# Access Compliance Report

## Public Rights-of-Way

### (Curb Ramps)

| Intersection ID: 25405 | Main Street: MARMOT_POINT_LN | Cross Street: PROVIDENCE_PLANTATION_LN | Location: NW           |

| ADA ID: 168D562C6C04   | Ramp Type: BlendTrans1       | Initial Pass/Fail: Fail                | Overall Compliance: No |

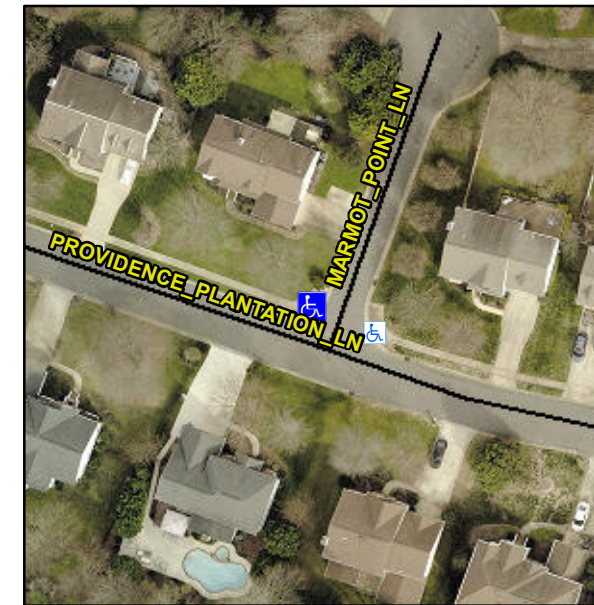
**Not Found, R304.5.1, R304.5.3**

| Compliance | Description           | Data  | Compliance | Description                 | Data |
|------------|-----------------------|-------|------------|-----------------------------|------|
| No         | Ramp Width (in)       | 29.0  | No         | BlendTrans XSlope (%)       | 6.9  |
|            |                       |       | No         | Curb Slope (%)              | 11.6 |

**Remove & Replace Curb Ramp With Two New Directional Ramps or Equivalent.**
